### ADDENDUM 1

CSP 22-92

## Cavazos Elementary School Heating & Air Condition (HVAC) Improvements Funded through the Elementary & Secondary Emergency Relief (ESSER) Funds May 31, 2022

## Addendum

DATE: 05/05/2022  
 DRAWN BY: DBR  
 CHECKED BY: DBR  
 PROJECT NUMBER: 218007.005  
 SHEET TITLE: LEVEL 1 ELECTRICAL POWER PLAN - AREA A  
 SHEET NUMBER: EP2.11A

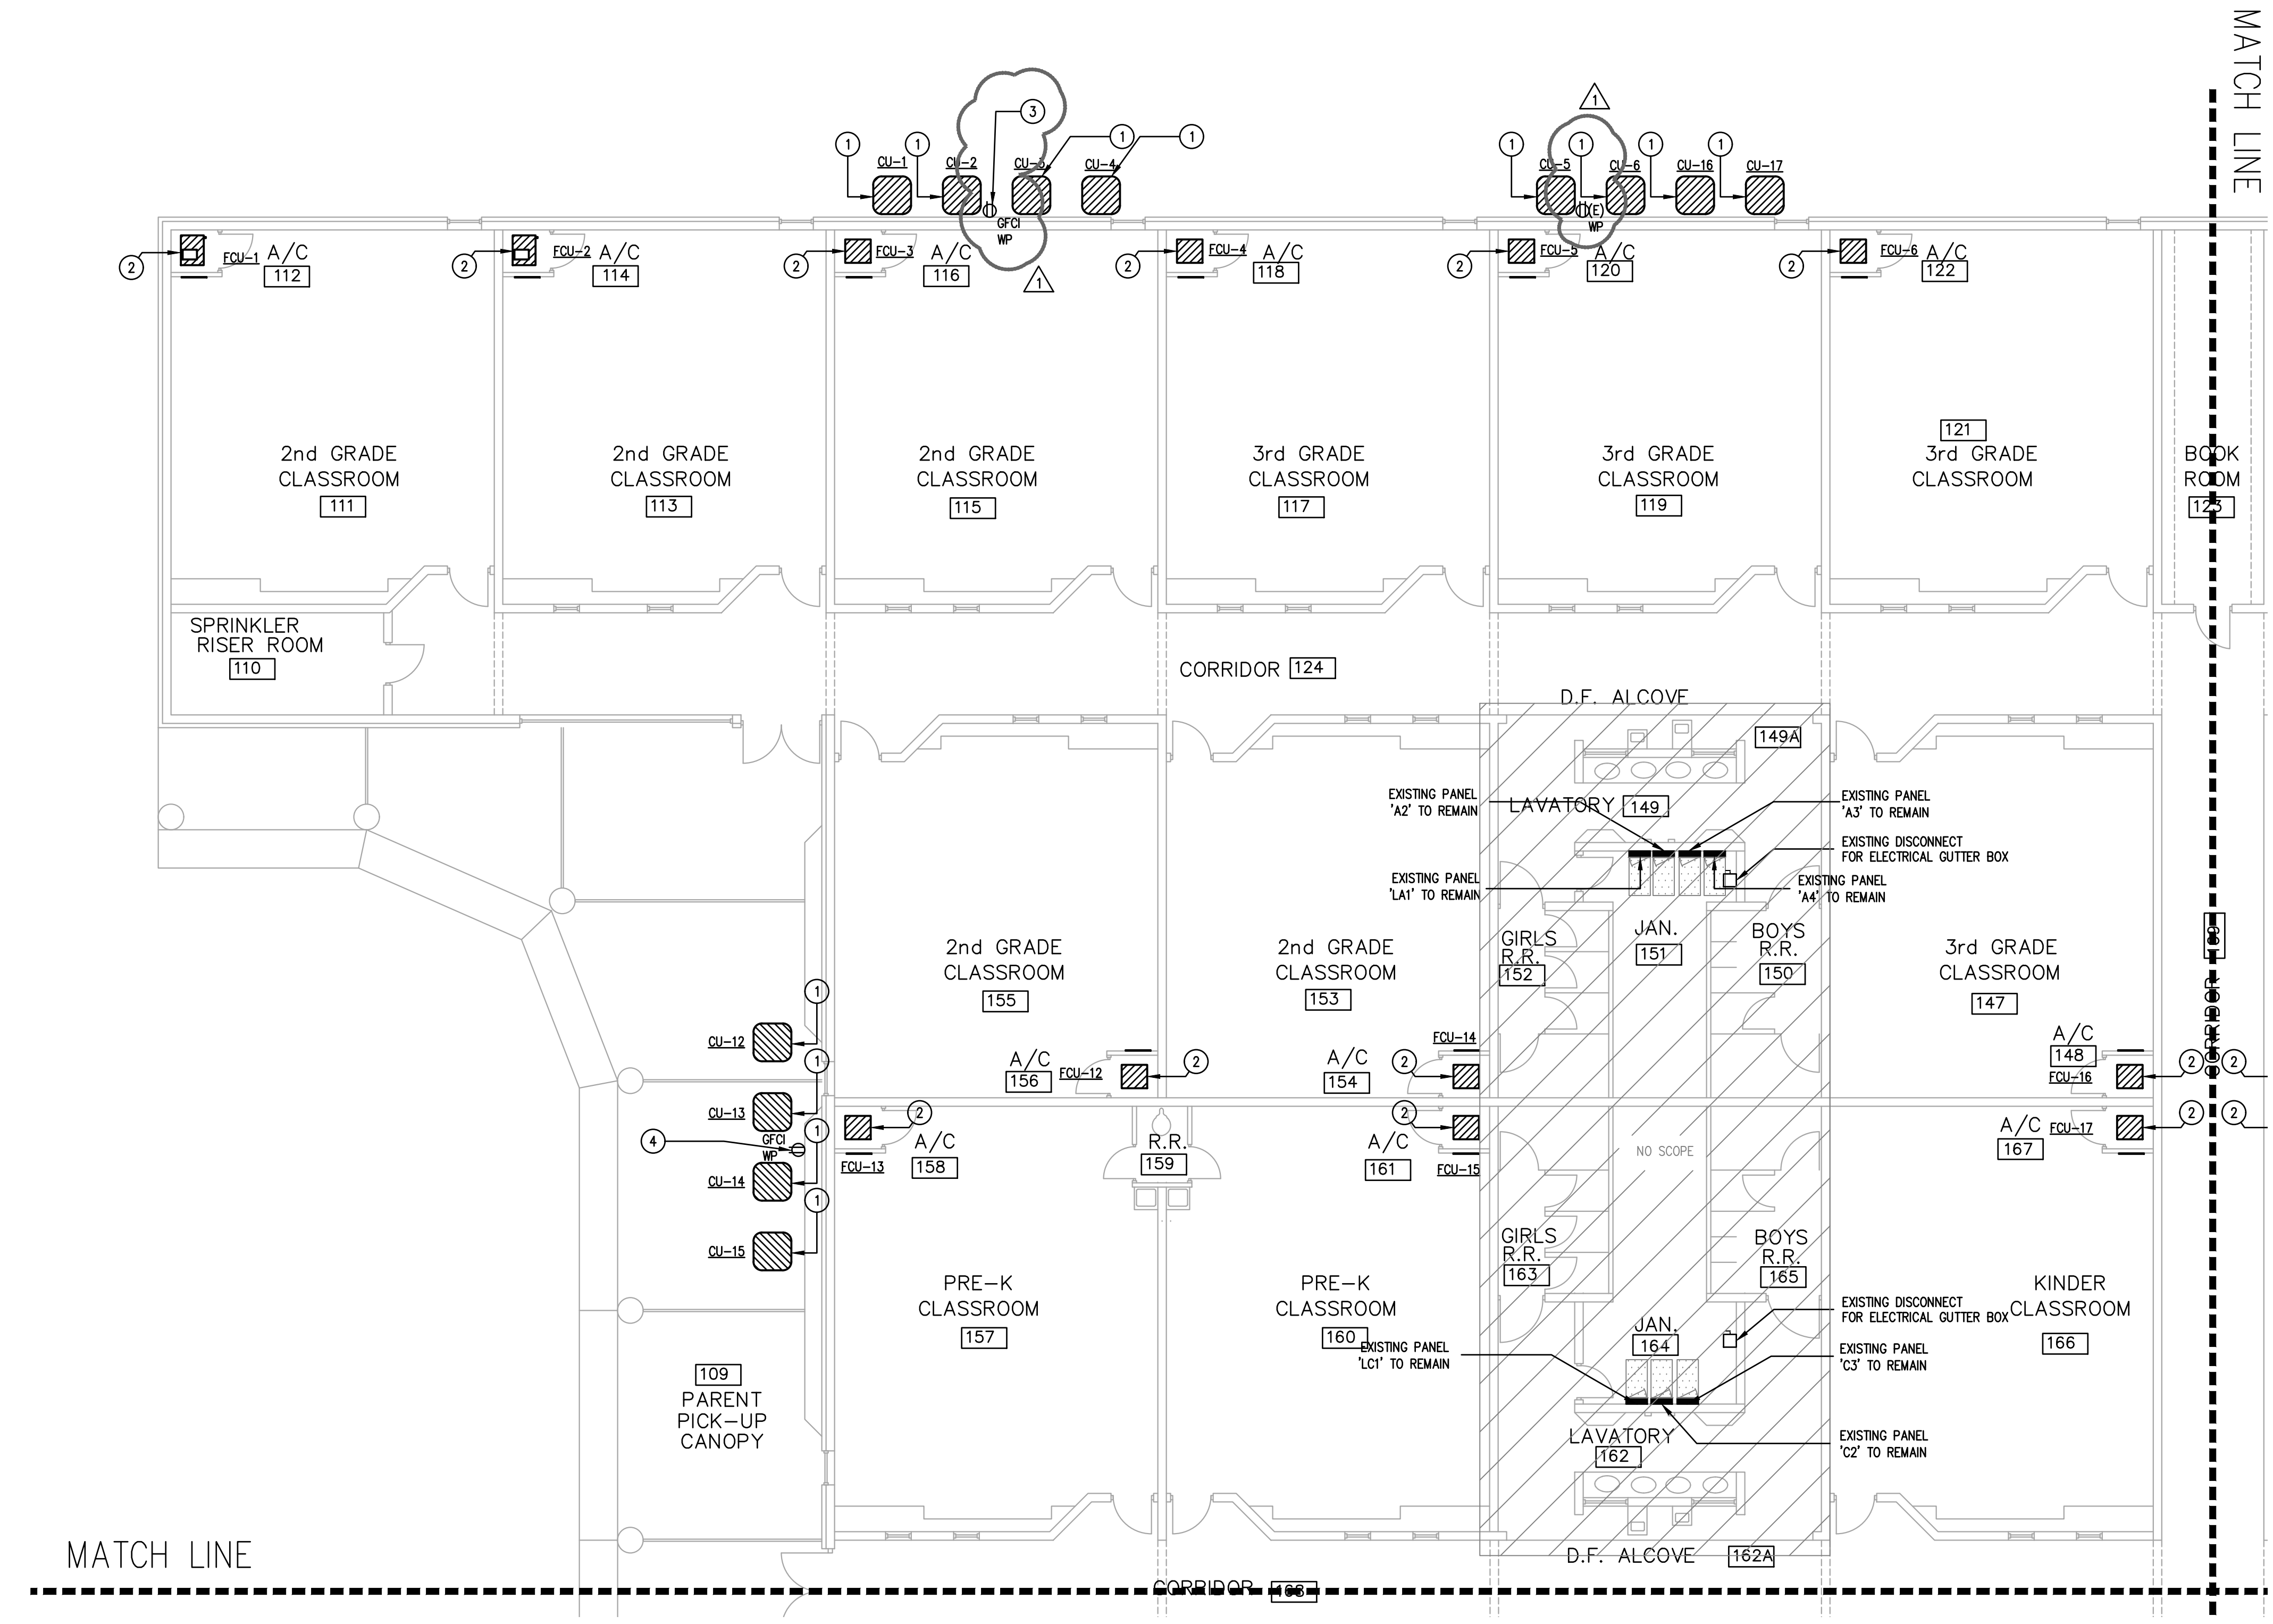
**Item 16 EP2.11A – LEVEL 1 ELECTRICAL POWER PLAN – AREA A**

- A. Revised keyed notes.
- B. Added keyed notes 3 and 4.

DATE: 05/05/2022  
 DRAWN BY: DBR  
 CHECKED BY: DBR  
 PROJECT NUMBER: 218007.005  
 SHEET TITLE: LEVEL 1 ELECTRICAL POWER PLAN - AREA B  
 SHEET NUMBER: EP2.12B

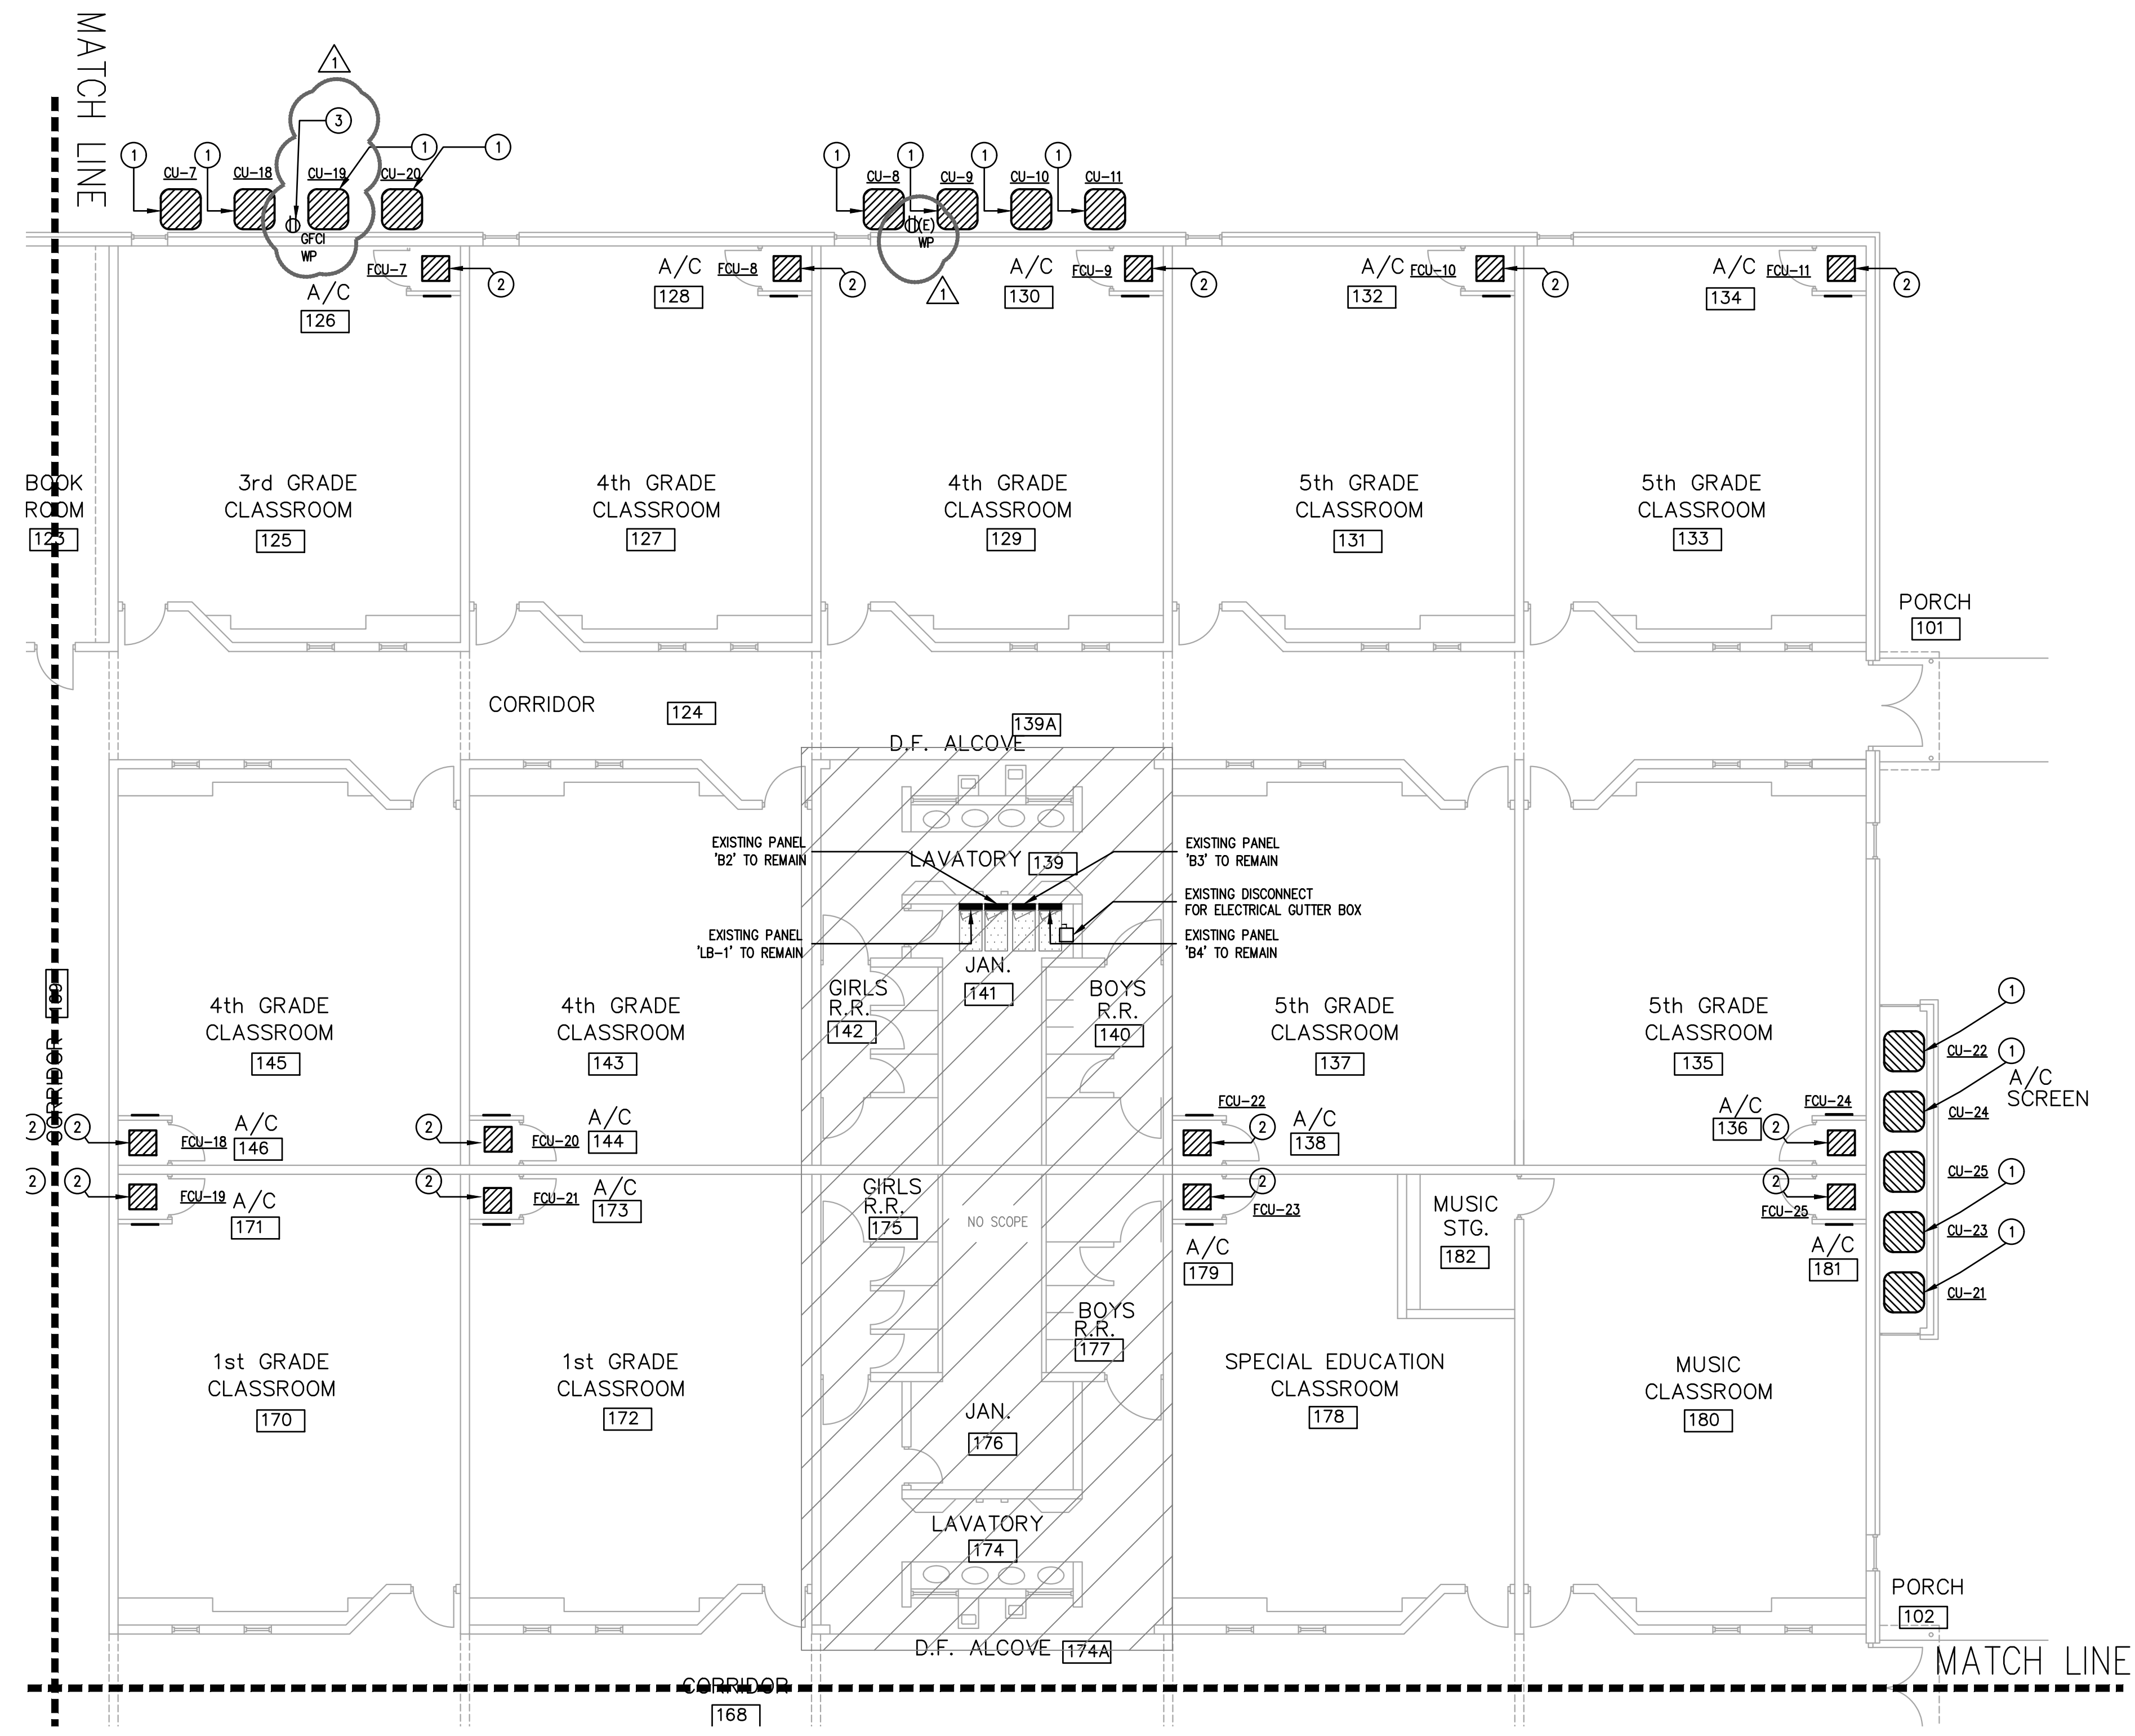
**Item 17**            **EP2.12B – LEVEL 1 ELECTRICAL POWER PLAN – AREA B**

- A.     Revised keyed notes.
- B.     Added keyed note 4.

DATE:	05/05/2022
DRAWN BY:	DBR
CHECKED BY:	DBR
PROJECT NUMBER:	218007.005
SHEET TITLE:	LEVEL 1 ELECTRICAL POWER PLAN - AREA C
SHEET NUMBER:	EP2.13C

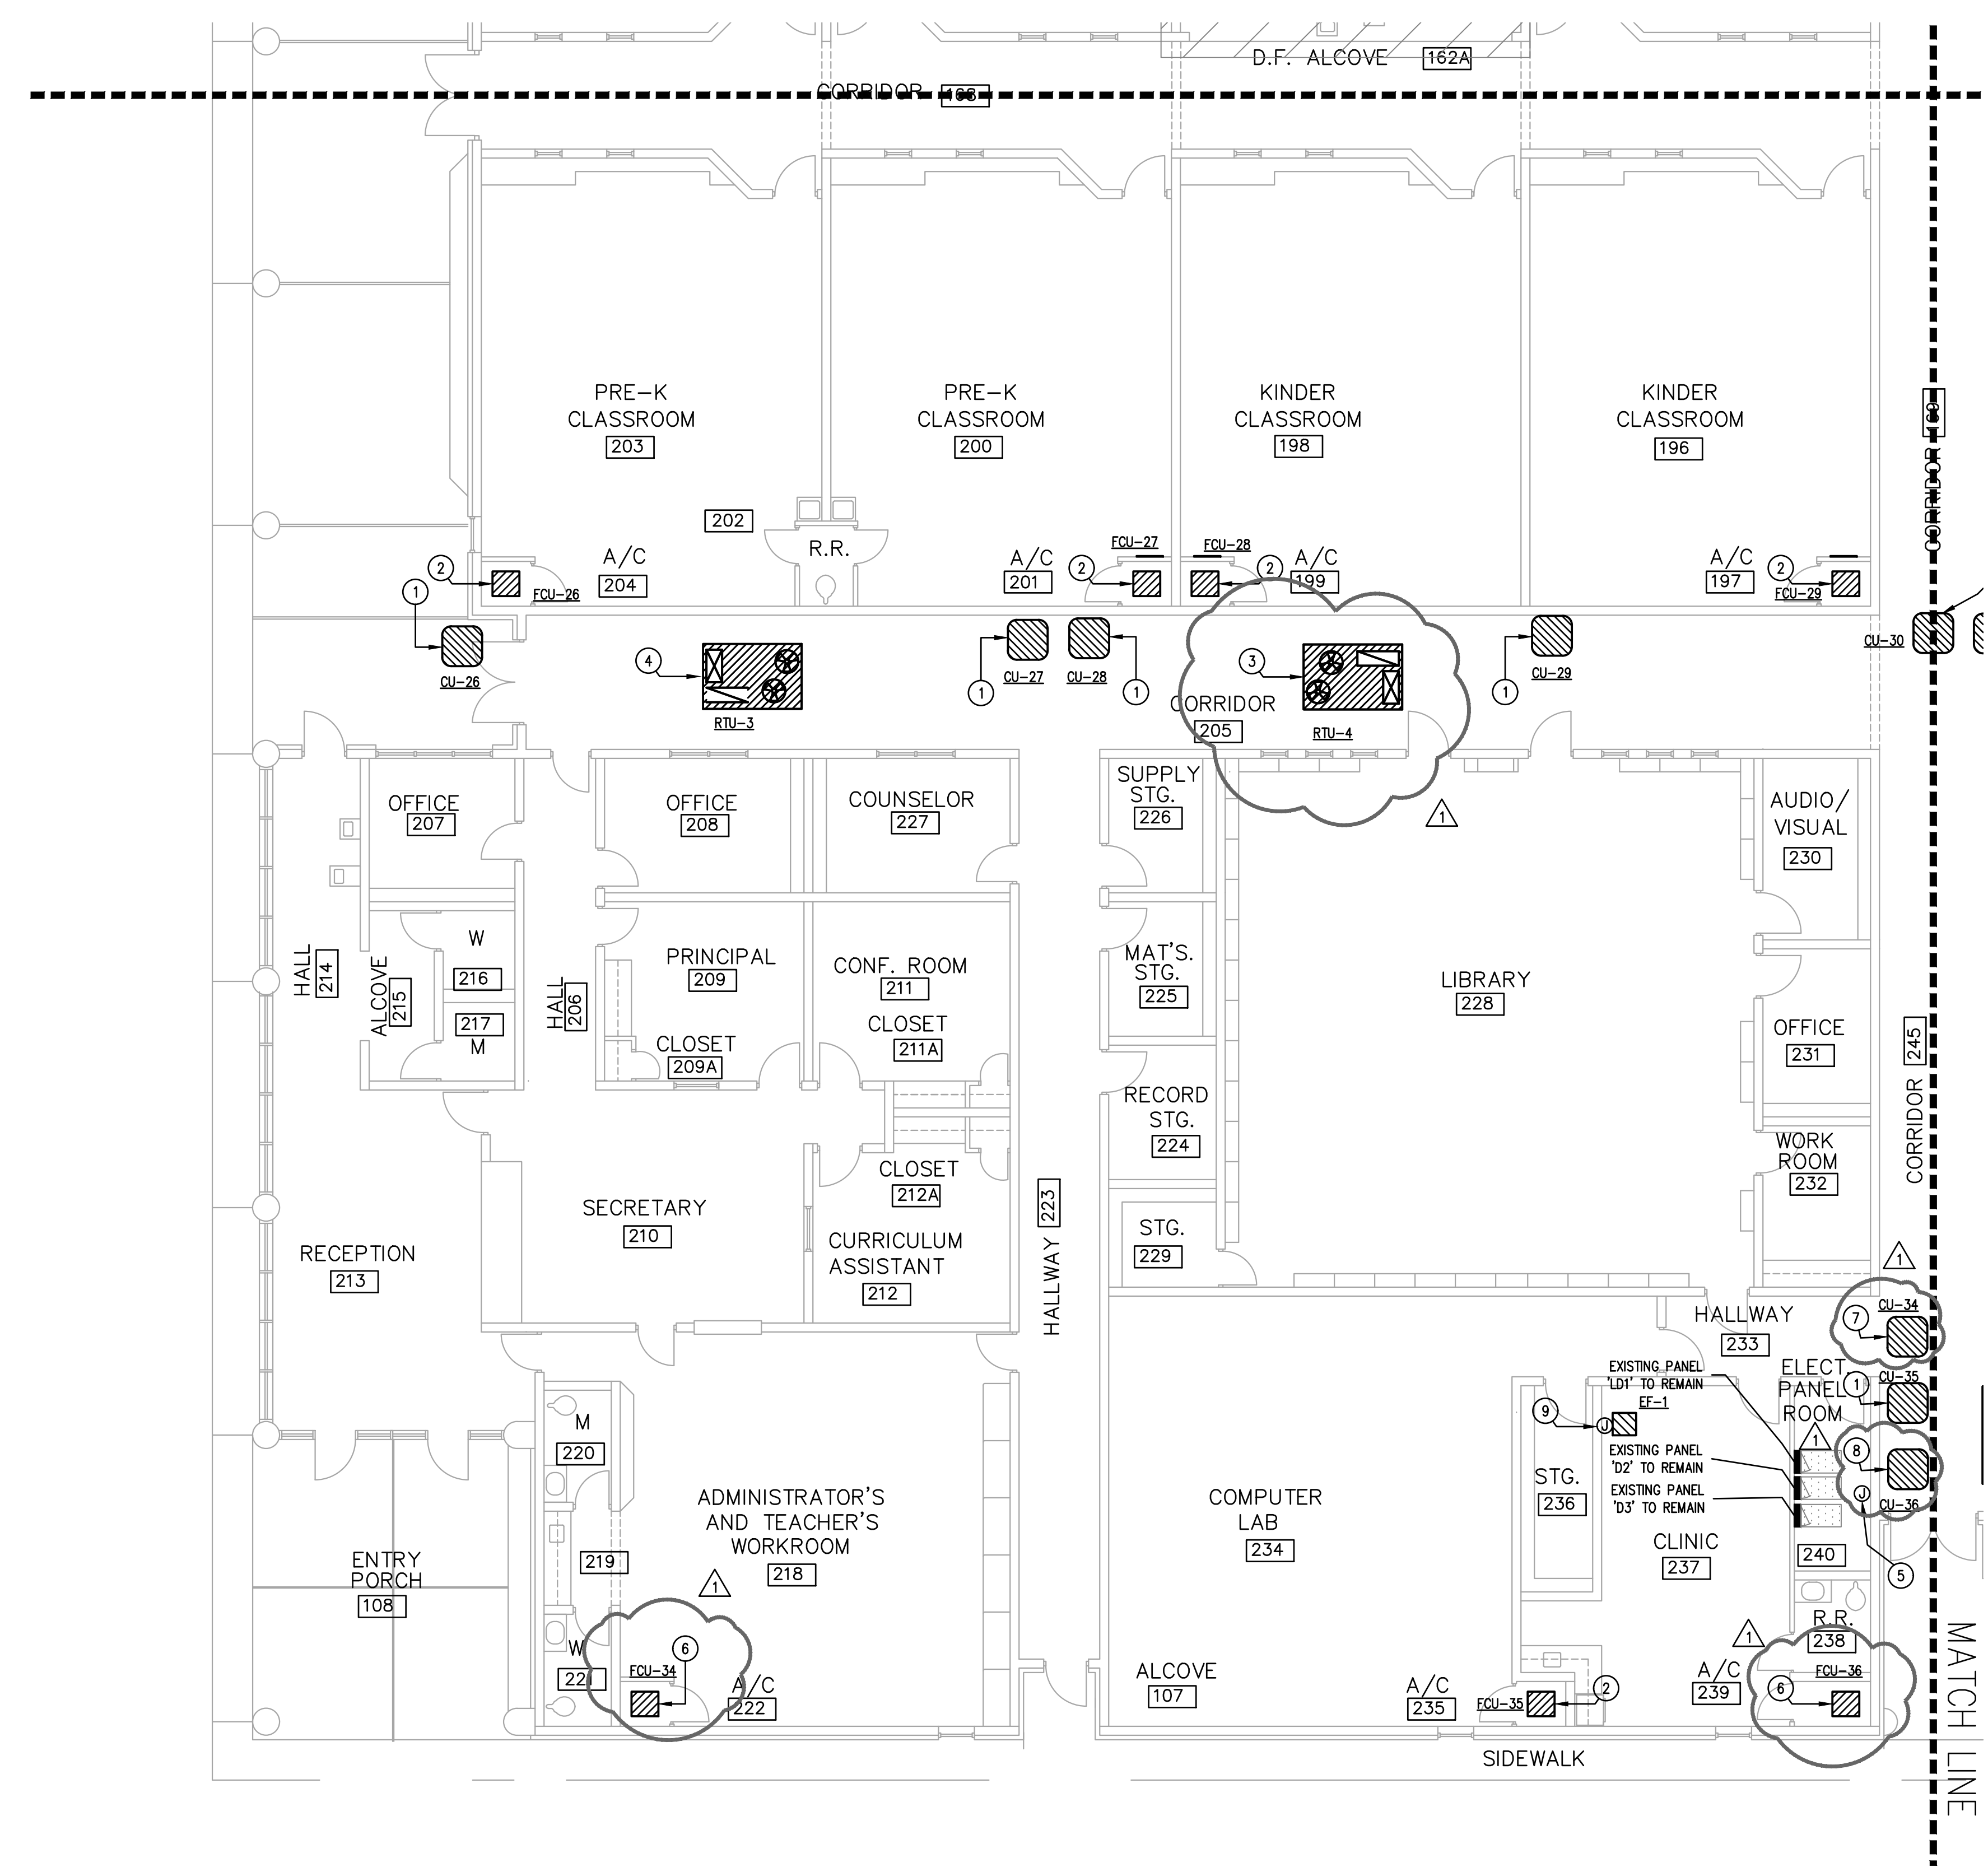
**Item 18**            **EP2.13C – LEVEL 1 ELECTRICAL POWER PLAN – AREA C**

- A.     Revised keyed notes.
- B.     Added keyed note 9.
